Access Compliance Report

Public Rights-of-Way

(Pedestrian Signals)

Intersection ID: N/A	Main Street:	Cross Street: N/A	Location: N/A
ADA ID: 5ED72B47A983	Signal Type: Two Push Buttons-Non APS	Overall Compliance: No	Severity Score: BTN 1:N/A BTN 2: N/A No BTN: N/A
Codes/Mitigation Info/Possible Solution		Field Measurements/Component Compliance

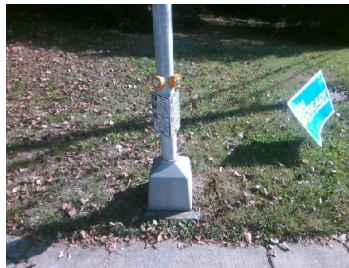
PROW/ADA: TMUTCD 4e.08, R404.2, R406.2, R404.7.3, R209.1

Yes	B 1 Clear Xing Direction?	ClearlyMarked	Yes	B 2 Clear Xing Direction?	ClearlyMarked
	B 1 Crossing Direction	To NW		B 2 Crossing Direction	To SW
Yes	B 1 DistanceTo XWalk (in)	0.0	Yes	B 2 DistanceTo XWalk (in)	0.0
No	B 1 DistanceTo Curb (in)	85.0	No	B 2 DistanceTo Curb (in)	89.0
Yes	B 1 Diameter (in)	2.0	Yes	B 2 Diameter (in)	2.0

Possible Solutions: Replace Signal Push Button With APS Button on New Post. Remove & Relocate Sign.
